Re: Monterey Peninsula Water Supply Project: Responses to (1) Appeals of the Planning Commission's Approval of the Project's Desalination Plant (PLN150889) and Carmel Valley Pump Station (PLN150653) and (2) Comment Letters Submitted to the Planning Commission

This Attachment A responds to three appeals submitted to the Board of Supervisors: MCWD's appeals of Planning Commission Resolutions PLN150653 and PLN150889 ("MCWD Pump Station Appeal" and "MCWD Desal Plant Appeal," respectively), and PWN's appeal of Planning Commission Resolution PLN150889 ("PWN Appeal"). The Attachment also responds to comments submitted to the Planning Commission at or before its April 24, 2019, hearing by MCWD ("MCWD April 23, 2019 Letter"), the City of Marina ("Marina April 23, 2019 Letter"), and California Unions for Reliable Energy ("CURE April 23, 2019 Letter").

Figure 1. Relation of residuals and model calculated water levels for Model Layer 8 (900-Foot Aquifer), reproduced from Appendix E2 Figure 4.3b with trend line values expanded from one decimal place to two (the number of decimal places reported does not influence the conclusions).

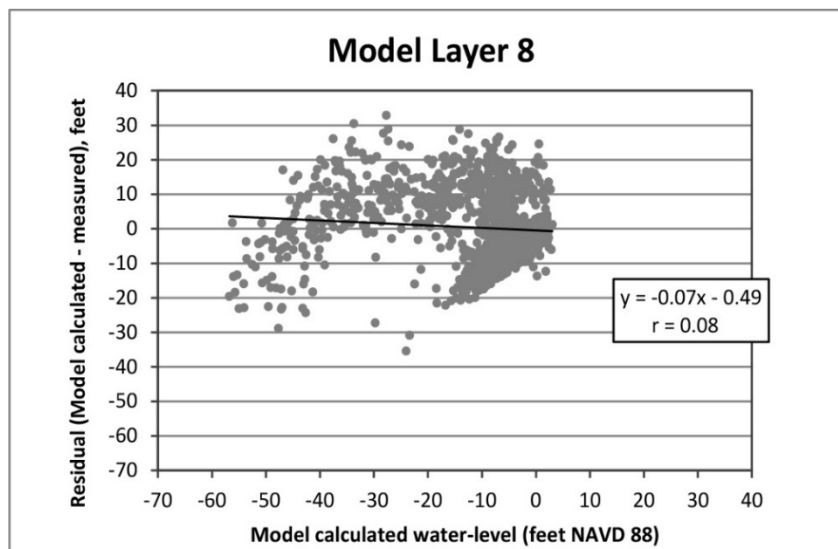
“That is the case in Figure 3, which does not reflect data corruption for the 900-foot aquifer, but not in Figure 2, which does, for the 180-Foot Aquifer (see the red trend line in each figure). Where and how the data corruption of model output for the 180-Foot Aquifer occurred are questions to which the FEIR/EIS, like the draft immediately preceding it, has tried but failed to provide answers that can withstand scrutiny. Figures 2 and 3 tell the story.”

The commenter’s accusations of data tampering stem primarily from his interpretation of a correlation of model errors (residuals) with model-calculated water levels in a single aquifer (the “180-Foot Aquifer”). The correlation that is claimed to be evidence of data tampering is actually related to the availability of only poor quality model inputs, resulting in model bias. In this case, model bias means that the differences between the model-calculated water levels and the measured water levels – these differences are referred to as the model errors or “residuals” – are not consistent over the range of model-calculated water levels; the residuals (or errors) increase with increasing model-calculated water levels. Ideally, for a given model layer there should be both positive and negative residuals (model-calculated water levels fall equally and unpredictably higher and lower than measured water levels), and a plot showing the residual values on the y-axis and the model-calculated values on the x-axis should be approximately horizontal and scattered around zero for the entire range of model-calculated values. This would illustrate that the residuals are random and unpredictable, and there is little to no correlation. For example, the plot of Model Layer 8 for the 900-Foot Aquifer (this is described as the “Deeper Aquifers” in the Final EIR/EIS) shown below in Figure 1 does not show model bias. That is, the values of the residuals do not show a trend (correlation) as model-calculated water levels increase.

Figure 2. Relation of residuals and model calculated water levels for model layer 4 (180-Foot Aquifer), reproduced from Final EIR/EIS Appendix E2 Figure 4.3b with trend line values expanded from one decimal place to two (the number of decimal places reported does not influence the conclusions).

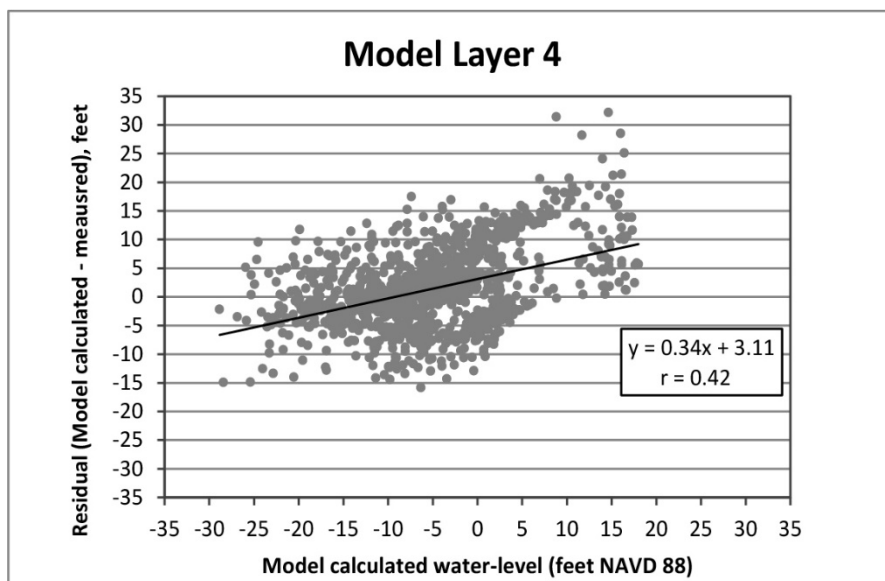
"Common statistical practice is to represent correlations to two decimal places and, following this practice, the actual correlation between predictions and errors for the 180-foot aquifer is equal to -.45, as shown in Figure 2 of the Appendix."

As shown in Figure 2 above, the correlation coefficient ("r") is 0.42 for Model Layer 4. The difference between 0.4 and 0.42 had no influence on the interpretation of the results.

Figure 6. Residuals versus modeled calculated water levels for a single well 19Q03 located in Model Layer 8.

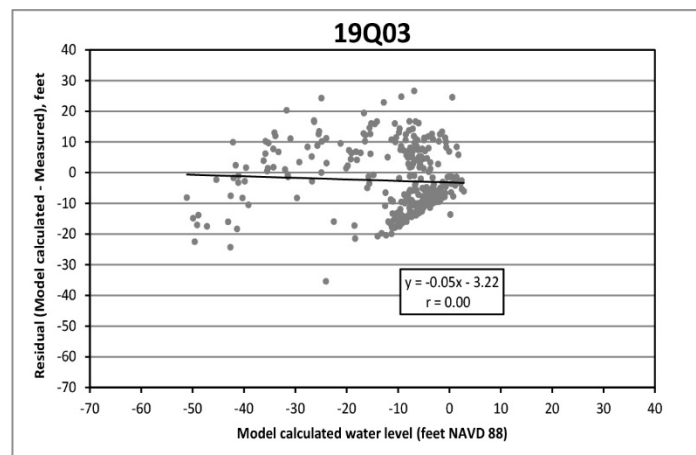
“The U-shaped relationship in Figure 3 for the 900-foot aquifer shows that zero correlation can exist between predictions and errors even when they are not independent of each other: In this case, as one goes up the other first goes down and then goes up (like the letter U). When predictions, tagging observed water elevations, are relatively low, as they are in the later years of data collection, a plot of errors against predictions for those years of 900-foot aquifer data would look very much like the one for the 180-foot aquifer in Figure 4.3d of Appendix E2 of the FEIR/EIS even though for the complete 900-foot aquifer data set zero correlation exists between predictions and errors. (The error trend would be downward rather than upward, as it is in Figure 4.3d, because HydroFocus determined error incorrectly, as shown earlier.) If HydroFocus had used such a plot for the 900-foot aquifer to explain non-zero correlation, it would have explained something that did not exist. The non-zero correlation for the entire 180-foot aquifer data set is evidence of the corruption of output data, nothing else. A good place to look for the source of that corruption is the computer program that selectively transferred the MODFLOW output to a Microsoft Excel spreadsheet, which HydroFocus and the other consultants used to analyze the results.”

These figures confirm that the model bias identified in Appendix E2 is limited to Model Layer 4 and show that it is caused by the timing and magnitude of shift between seasonal peaks. The model-calculated seasonal peaks are the result of model inputs – not data tampering. Specifically, the timing and magnitude of pumping and recharge specified in the model for extraction wells in Model Layers 4 and 8 were originally derived from the SVIGSM. Using the NMGWM in a superposition mode for the EIR/EIS analysis eliminated the model bias caused by the poor quality SVIGSM-generated data.

Figure 1. AEM Study Results and Water Quality Conditions

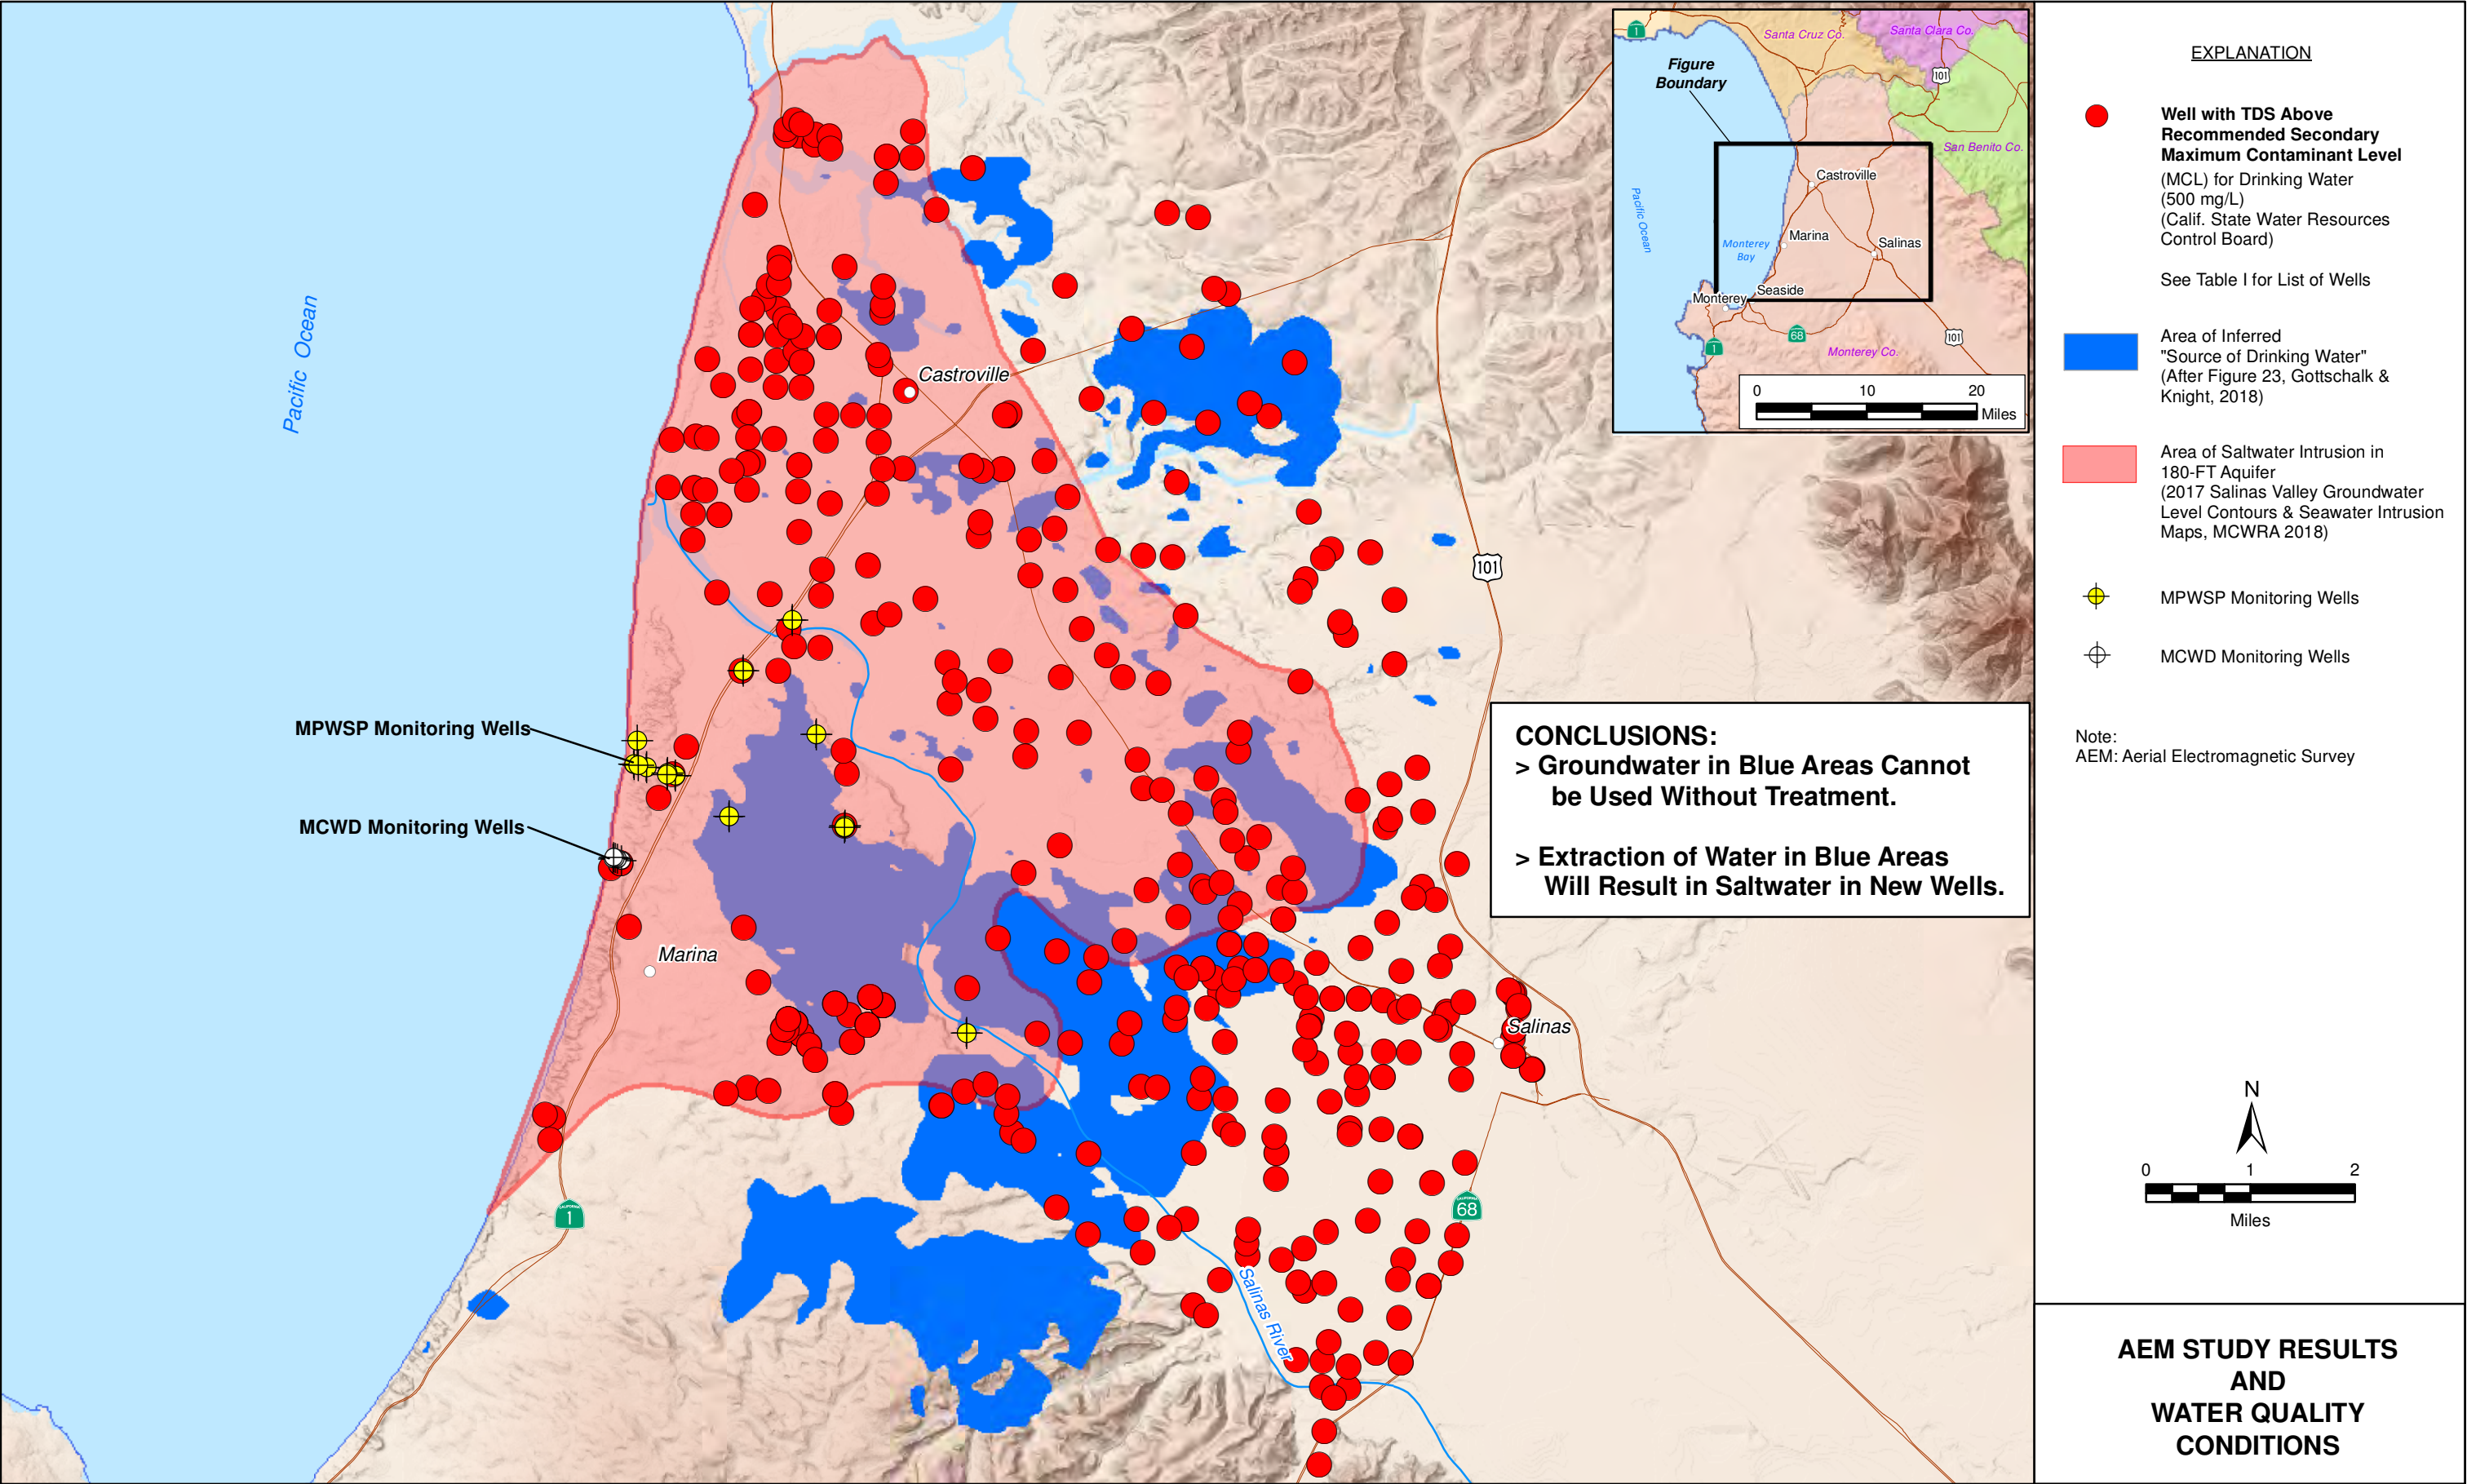
irrigation. Figure 1 in this comment letter was prepared with publicly and readily available data. The Figure shows wells with measured TDS concentrations above the recommended maximum contaminant level for TDS for public drinking water.

| Figure 1 | Comparison of AEM Profile with Field/Lab Based Chloride Concentrations |

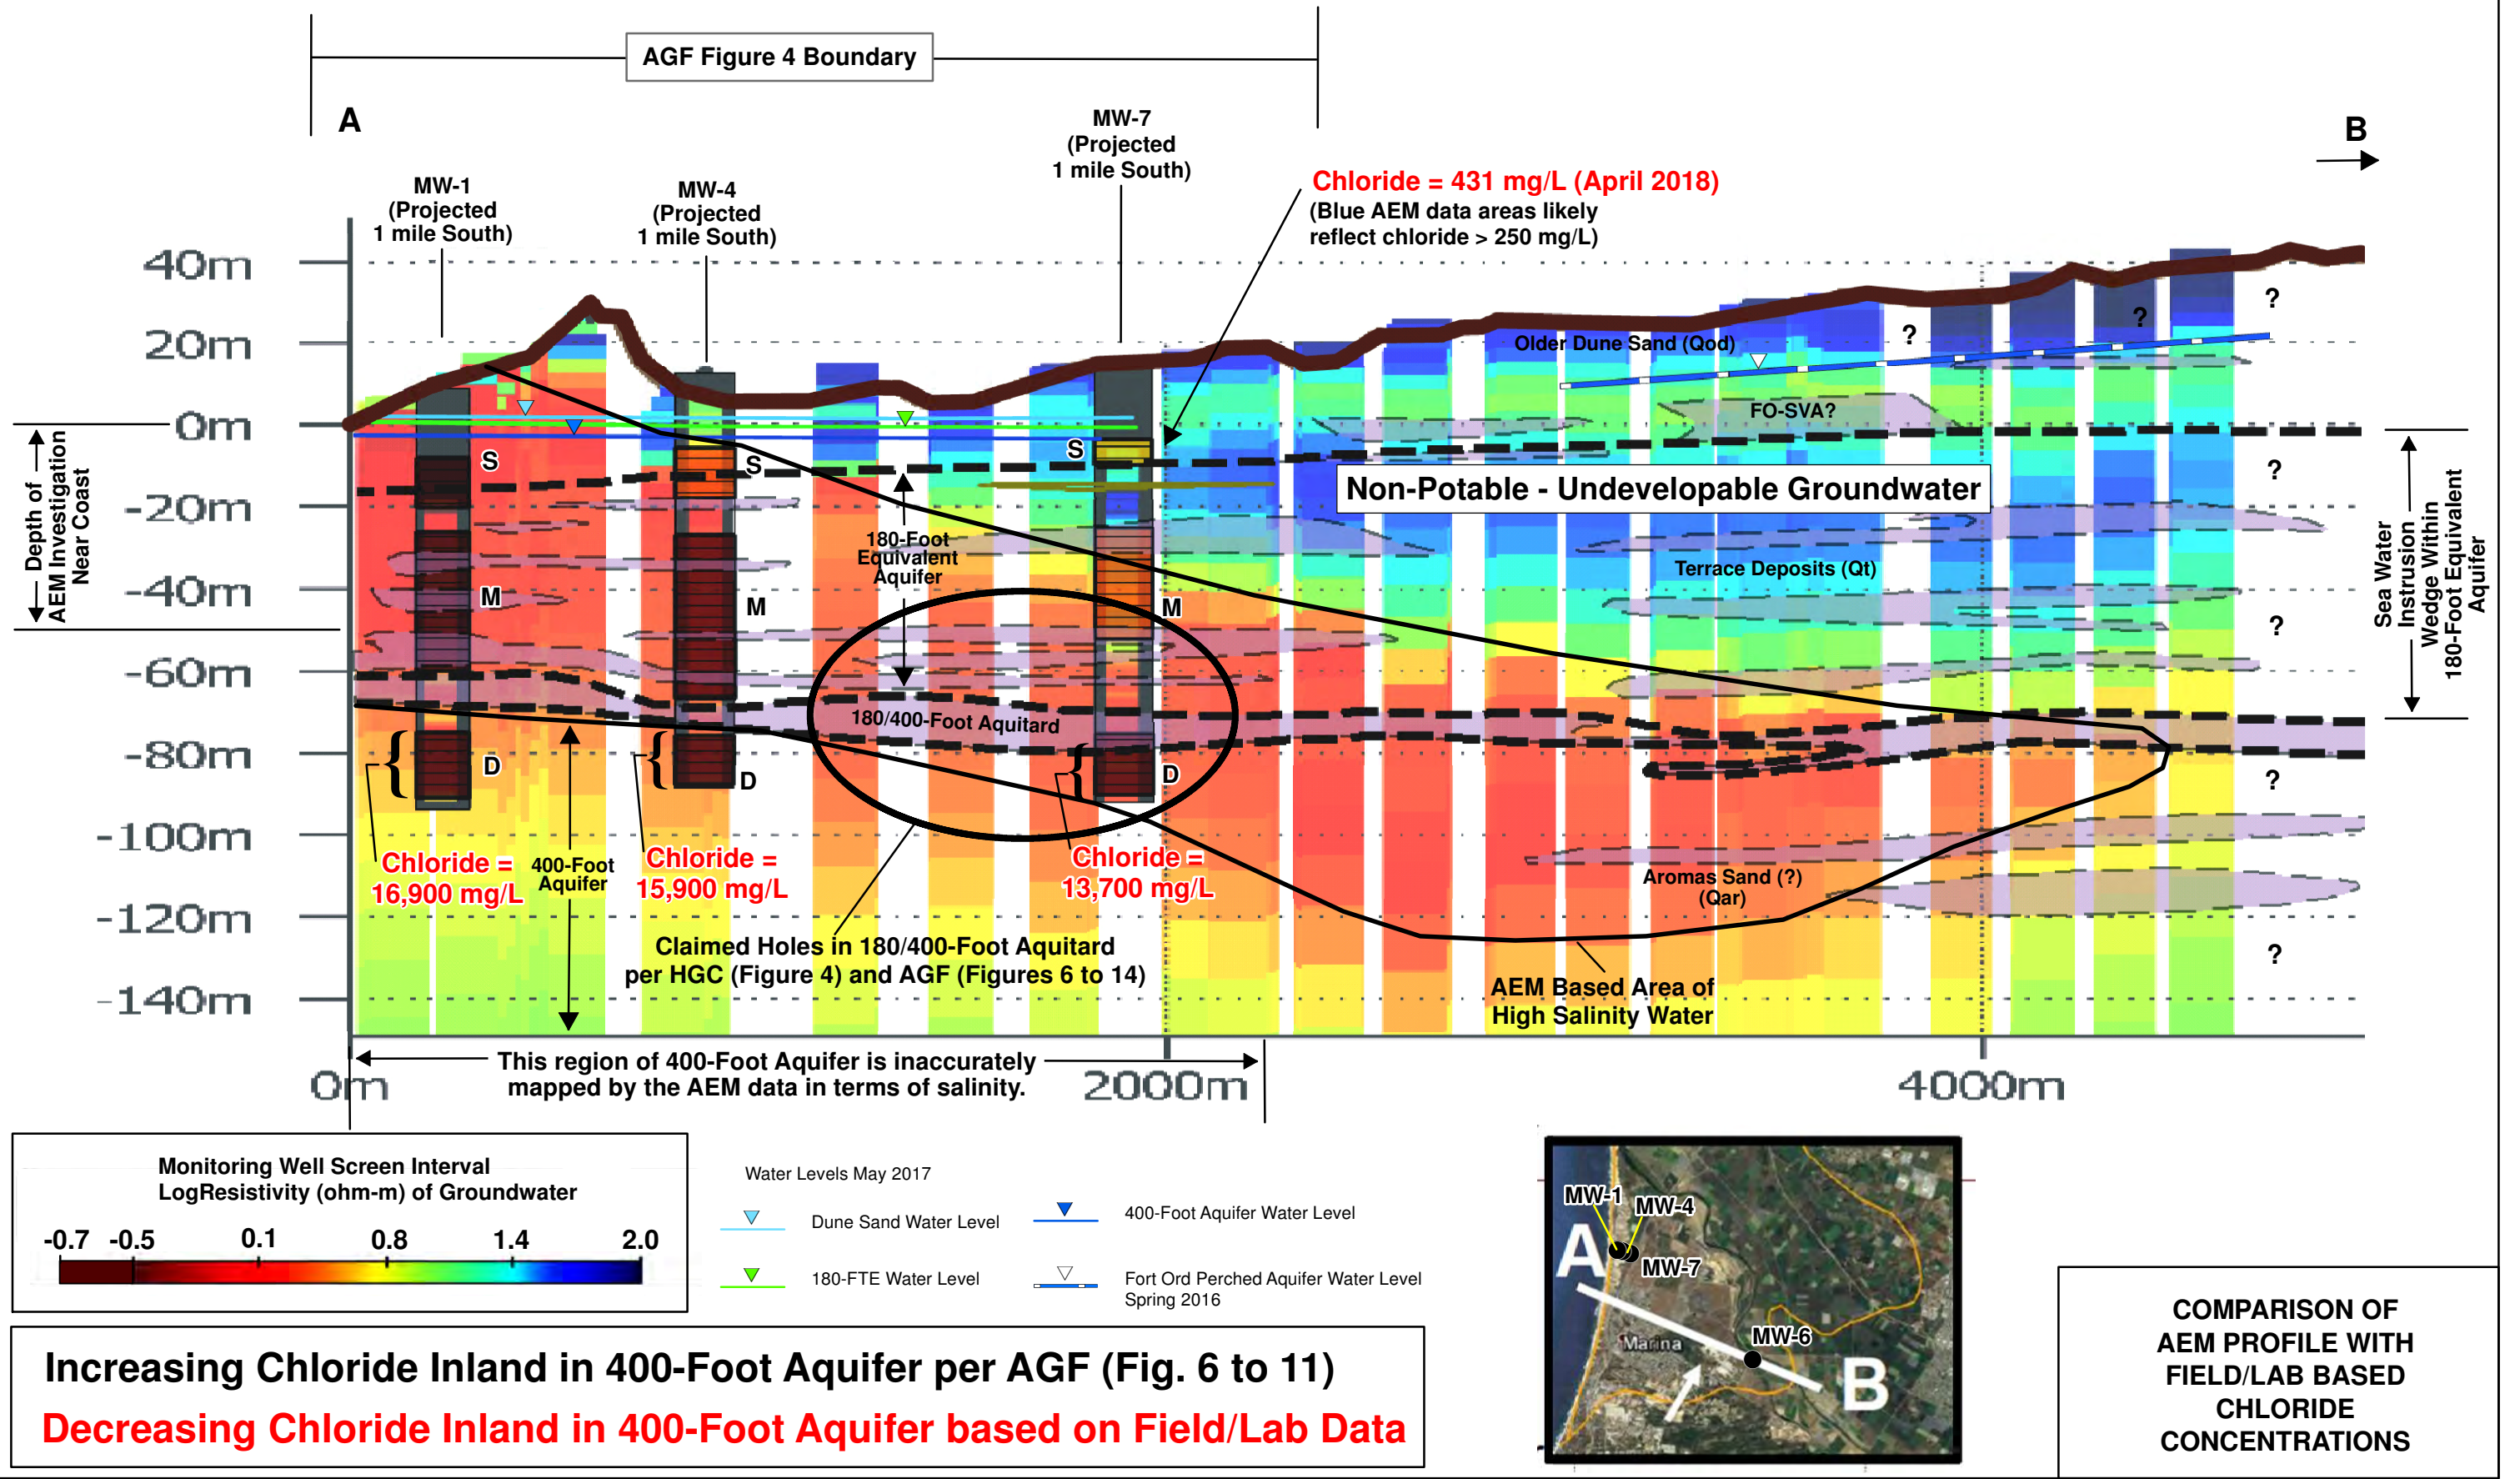
HWG Response: *There are a few important points to discuss here, some of which are illustrated on the attached **Figure 1**. First is that the depth of investigation (DOI) near the coast was limited and did not extend to or through the 180/400-Foot Aquitard or into the underlying 400-Foot Aquifer (see page 13 and Figures 4 and 5 from Final AEM Report). Therefore, the inverted apparent bulk resistivity shown for 180/400-Foot Aquitard and 400-Foot Aquifer west of MW-7 (to the left of MW-7 on the figure) is unknown and should not even be shown on this profile (i.e., the AEM imaging of the 400-Foot Aquifer west of MW-7 is invalid). Second, we note that even attempts to extend apparent inverted bulk resistivity below the DOI in MW-1 and MW-4 (Figures 4 and 5 of Final AEM Report) do not match particularly well with the lower borehole resistivity (implying higher salinity, although not accounting for lithology) in the top of the 400-Foot Aquifer. Third, there is no calibration of AEM data to the 400-Foot Aquifer in this area even where MPWSP borehole data and well data are available. This is due to a combination of the limited DOI west of MW-7 and the fact that MPWSP borehole well data only penetrate the upper 50 feet of the 400-Foot Aquifer throughout the area. Finally, review of field/lab based TDS/chloride concentrations in the upper portion of the 400-Foot Aquifer (MW-1D, MW-3D, MW-4D, MW-7D) show highest salinity at the coast and gradually decreasing salinity inland (from about 31,000 mg/L TDS and 17,000 mg/L chloride at the coast to about 27,700 mg/L TDS and 13,700 mg/L chloride at MW-7D). These water quality data from MPWSP monitoring wells in the 400-Foot Aquifer stand in direct opposition to interpreted AEM data for the 400-Foot Aquifer (shown in HGC Figure 4), which shows lower salinity at the coast and increasing salinity inland to MW-7D and further inland (see attached **Figure 1**). From a practical perspective, this (AEM data interpretation) can't be correct because salinity would not be greater further inland and away from the coast when seawater is clearly entering the aquifer from the seabed. Thus, monitoring well data proves the inverted AEM data interpretation is flawed and invalid in the 400-Foot Aquifer where HGC shows a flow arrow crossing the 180/400-Foot Aquitard in Figure 4.*
